July 7, 2020

**Re: Response to Review Comments and Supplemental Information
Woodside Condominium Retirement Community
WELD, LLC. – Applicant/Owner**

17070
JOB NUMBER:
1" = 50'
SCALE:
8-8-2019
DATE:
SHEET 2 OF 2
SWP-2

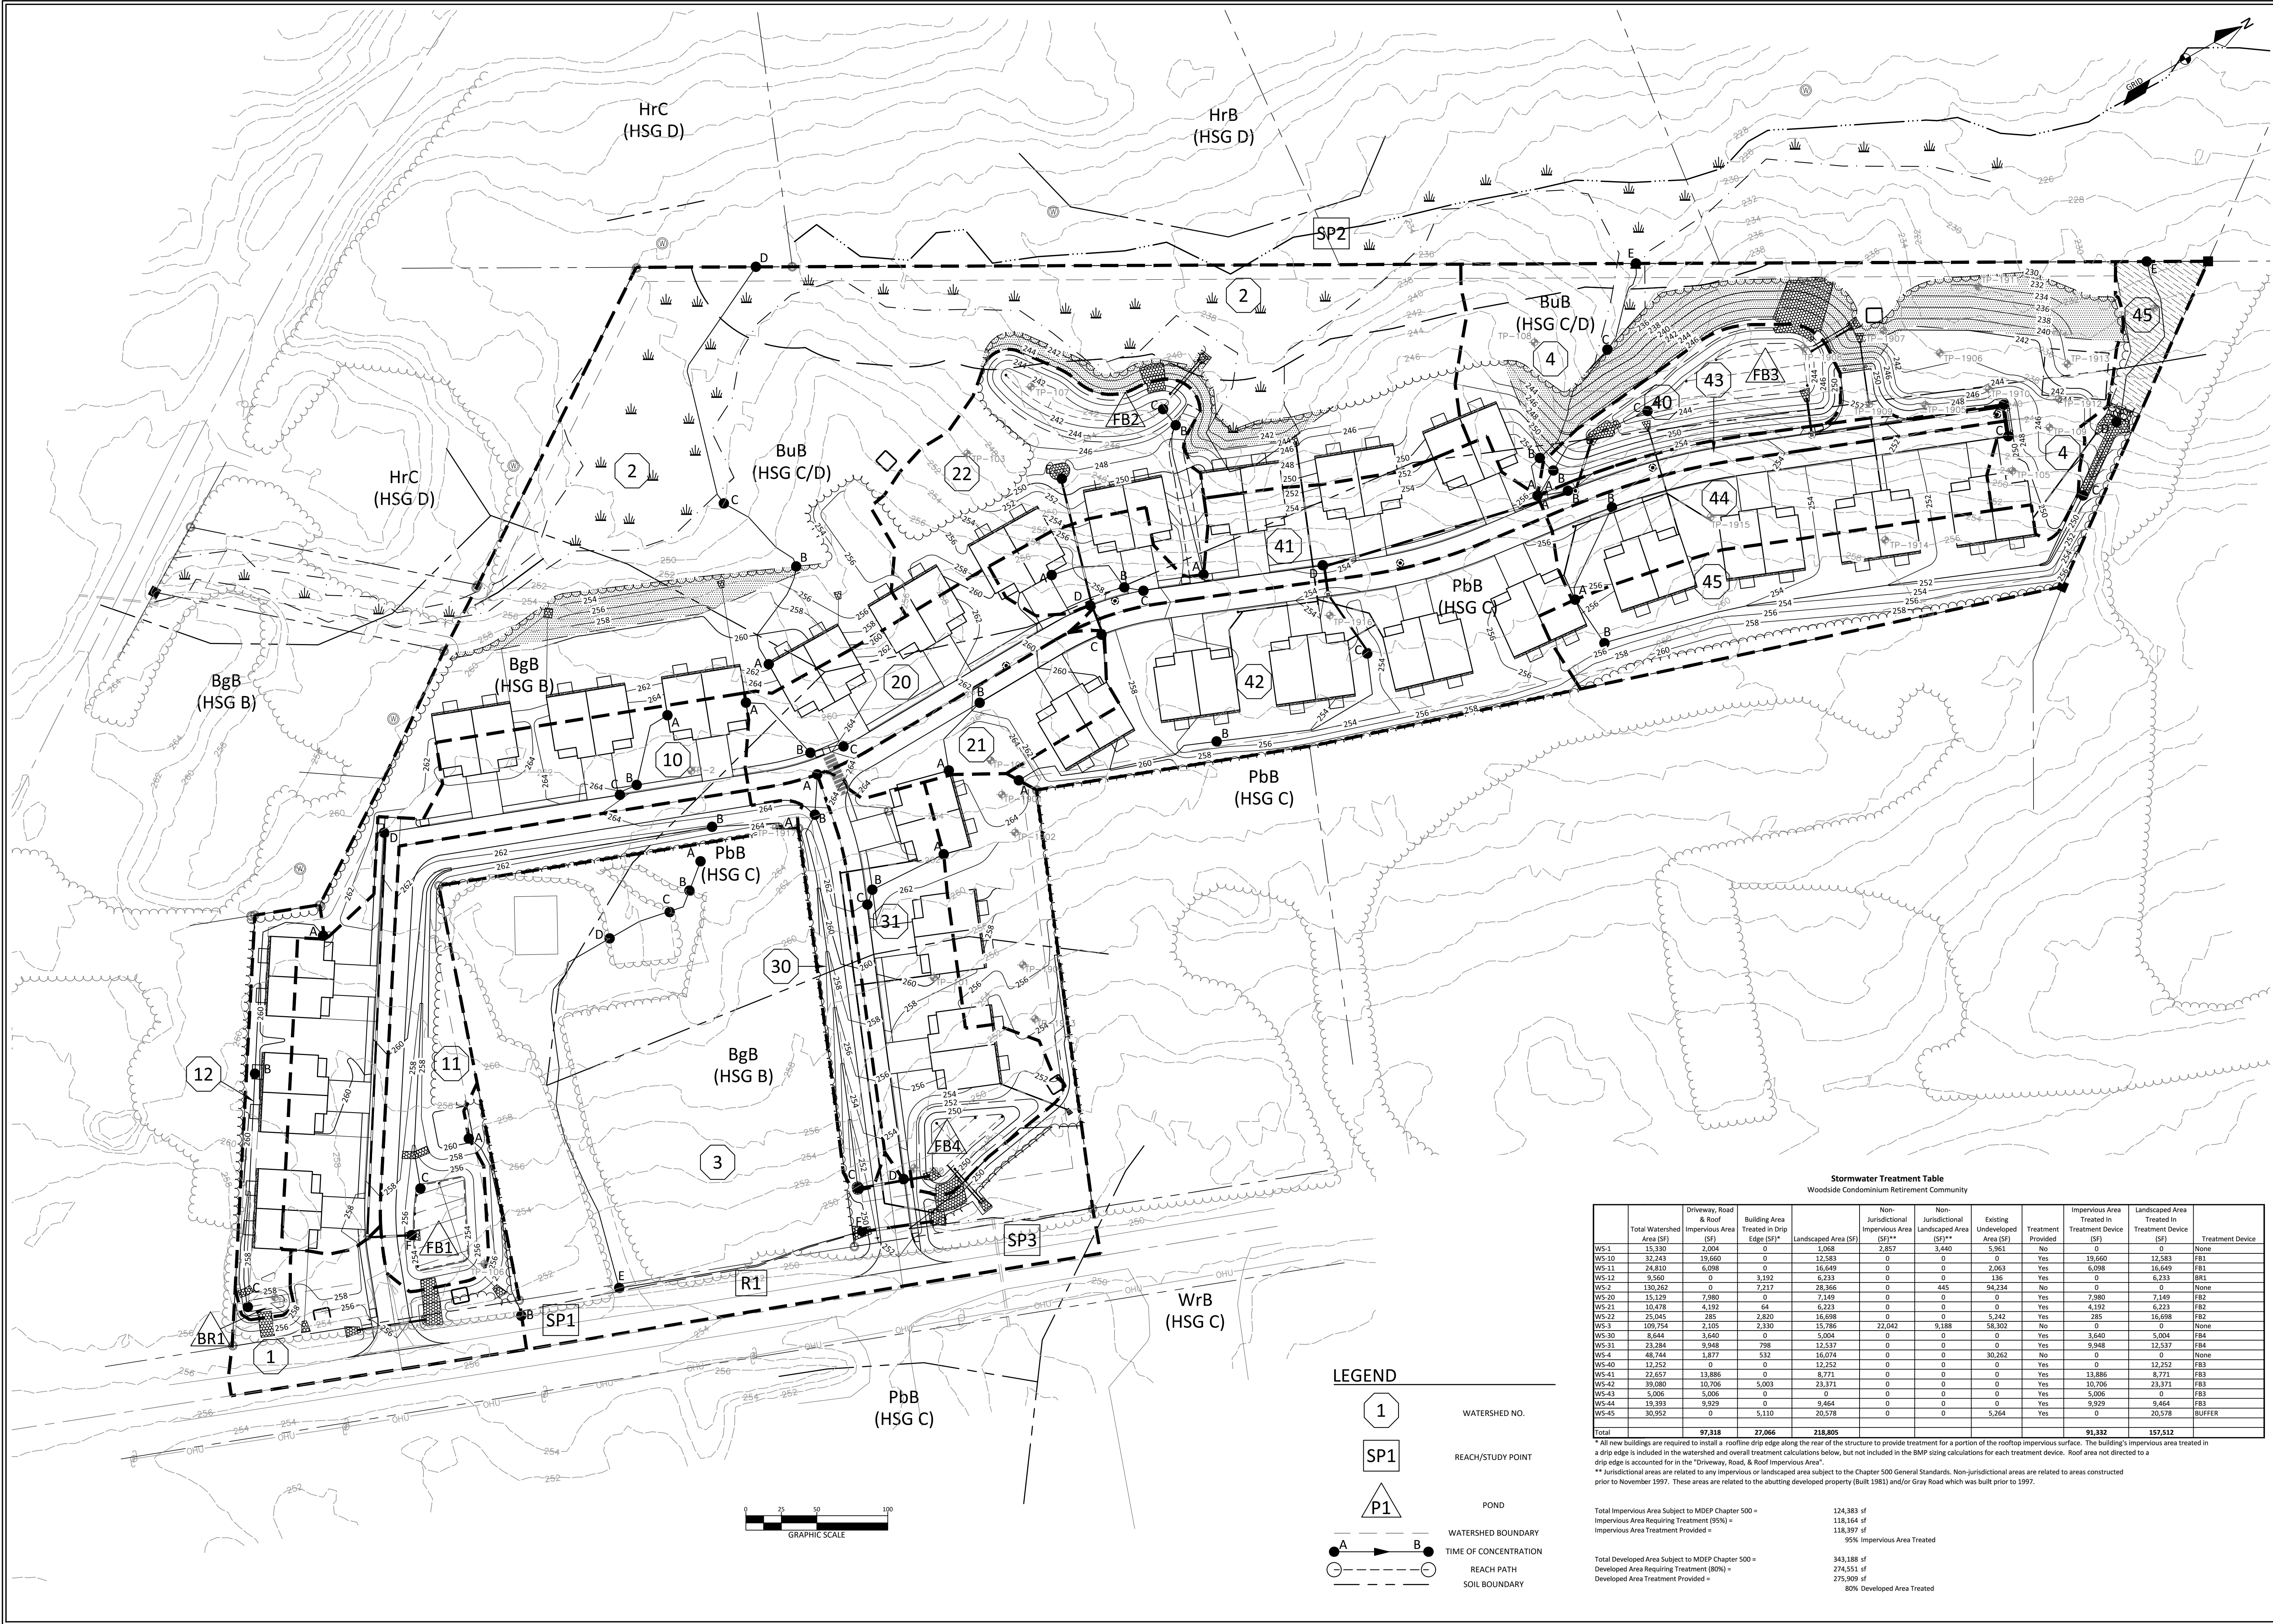
Comment 1: The one question/clarification that would be helpful is to indicate more clearly what infrastructure will be built as part of the amendment. The Amended Subdivision plan shows the 6 units, the road and a call-out for the leach fields, but there is no indication what stormwater infrastructure will be built as well as other road features such as the cross-walk from the sidewalk along Unity over to Conifer Drive. Will these items be part of the amended plan? Please clarify.

Response 1: Attached is a revised plan sheet GU-1 (Sheet 5 of 14) and plan sheet PP-2 (Sheet 10 of 14) that shows the phase line overlaid on the Grading and Utility Plan. The developer will construct all improvements shown within the Phase 1 area on these two plans, which includes the construction of the soil filter basin FB-4. The soil filter basin FB-4 was designed to provide water quality treatment and peak flow attenuation for all of the proposed improvements that will be moved from Phase 2 into Phase 1, as shown on the enclosed Watershed Map and depicted as subwatersheds 30 and 31.
